Subject

New Backflow Connector for the Bosch® Aftertreatment Diesel Exhaust Fluid (DEF) Dosing Unit.

Figure 1, Revised Backflow Connector, Part Number 4387302, Installed in the Aftertreatment DEF Dosing Unit

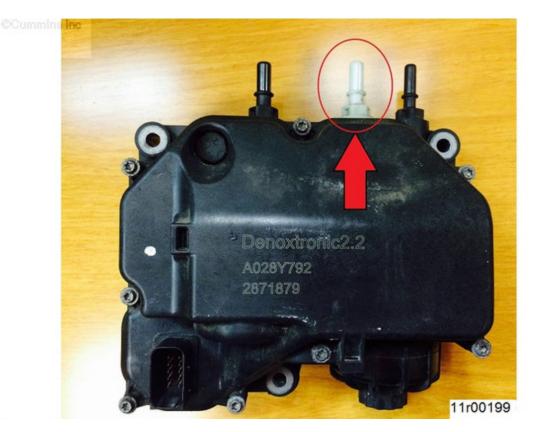
In some cases the aftertreatment Diesel Exhaust Fluid (DEF) dosing lines are **not** being fully purged during the purge cycle.

This can result in internal cracking of the aftertreatment DEF dosing unit and leakage of DEF. A revised backflow connector for the Bosch® aftertreatment DEF dosing unit has been released. The revised backflow connector will help to fully purge DEF from the DEF dosing lines and aftertreatment DEF dosing unit during the purge cycle.

Scenario 1 Resolution: The revised backflow connector, Part Number 4387302 must be used.
